UNITED STATES PATENT AND TRADEMARK OFFICE

10/542,935

Office Action Summary	Application No.	Applicant(s)	
	10/542,935	DAMBRICOURT, GERY BERNARD MARIE	
	Examiner	Art Unit	
	ERIK KASHNIKOW	1794

DETAILED ACTION

Fig. 5

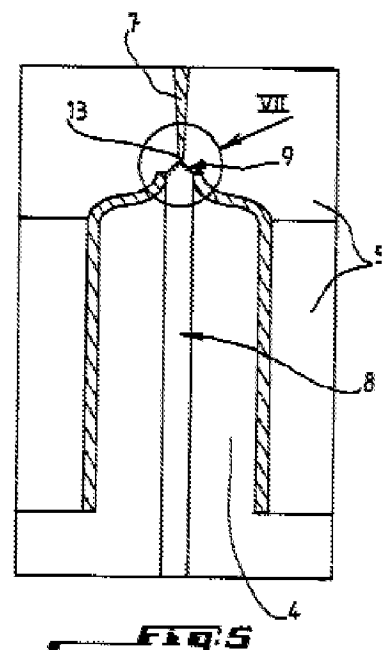
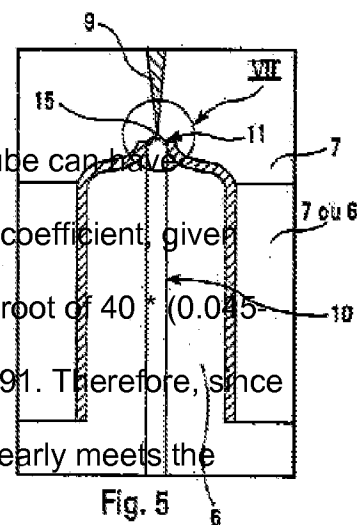
13. In regards to claim 53 Dambricourt 01 teaches that the tube be formed by injecting the polymers into a mold cavity which has a mold insert which contains a central part which has a free upper end and is centered on the tube (paragraph 0011). In regards to the requirement that the impression bears a resemblance to the tube skirt, while Dambricourt is silent regarding this the pictures shown by Dambricourt show the

same features as the pictures shown by Applicant (Fig 5 Dambricourt (top) Fig 5 applicant (bottom).

17. In regards to claim 61 and 66 Examiner is treating it as a product by process, for information on product by process see MPEP 2113. In regards to claims 61 and 66 Dambricourt 01 teaches a nozzle (a cavity through which the material is led into or out of the tube (paragraph 0111)) as is shown in figure 5 above. One of ordinary skill in the art at the time of the invention would recognize the area with the narrowing of the tube

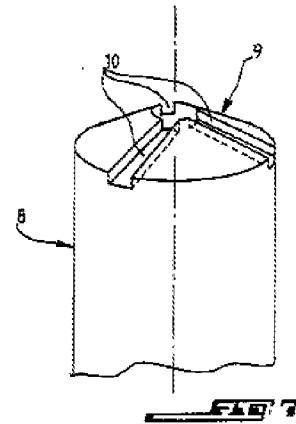
Dambricourt 01 also shows in the feed or supply channels forming an apex wall (Figure 7).

Fig. 9

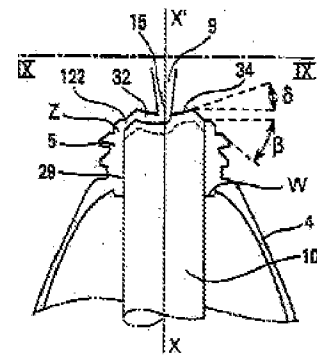
43. In regards to claims 67 and 69 Nishikawa shows another conventional embodiment which has the chimney feature described by Applicant (Figure 3).
